GEOCRES No. 411-69
DIST. 17 REGION NORTHERN
W.P. No. 911-71-01
CONT. No. 72-210
W. O. No. 72-P-11
STR. SITE No. 46-281
HWY. No. 17
LOCATION SUDBURY BYPASS AND
JUNCTION CREEK

FOOTING LAYOUT

FOUNDATION INVESTIGATION REPORT
For
Proposed Structure
At the Crossing of Junction Creek
and Sudbury Bypass
Township of Waters, District of Sudbury
District No. 17 (Sudbury)
W.O. 72-11011 -- W.P. 911-71-01

REVIEW OF DESIGN DRAWINGS:

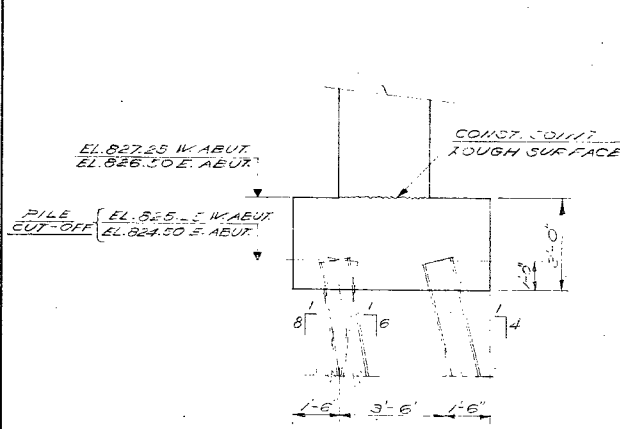
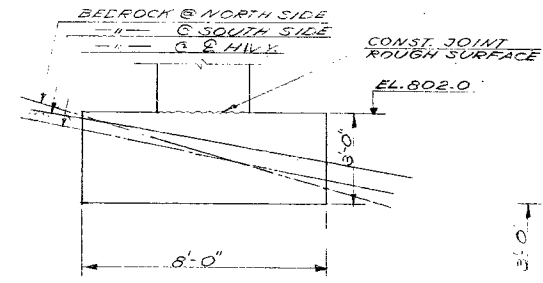
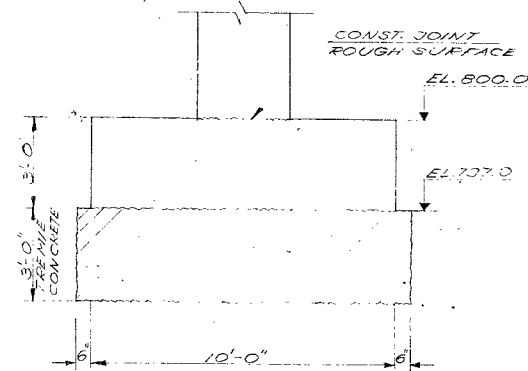
REDUCTION OF BLOWS/FT. (FROM 24 TO 14)
ALL PILES ALREADY SPLICED (EXCEPT ONE)

STOP PILE DRIVING WHEN Blows/ft is 30+
(CONSIDERING 0.5" REBOUND)

1. Does footing design comply with our report or subsequent memos? No
WEST ABOUT ON
PILES.
2. If answer to 1. is 'No', is present design acceptable? YES.
3. Has sufficient field work been done?
4. Are estimated pile lengths shown on Drawings correct? YES.
If not, make a new list.
5. If excavation of unstuitable soil is recommended, is this shown on drawings? N/A.
6. Are approaches designed in accordance with our report? No.
Check slopes and berm lengths. LONGITUDINAL SLOPES
SHOWN AS 1 3/4'.
7. Do you anticipate any construction problems?
i.e. dewatering, stability of temporary slopes or excavations. YES. DEWATERING
OF EAST PIER.
8. Summarize your comments; on separate sheet is necessary.
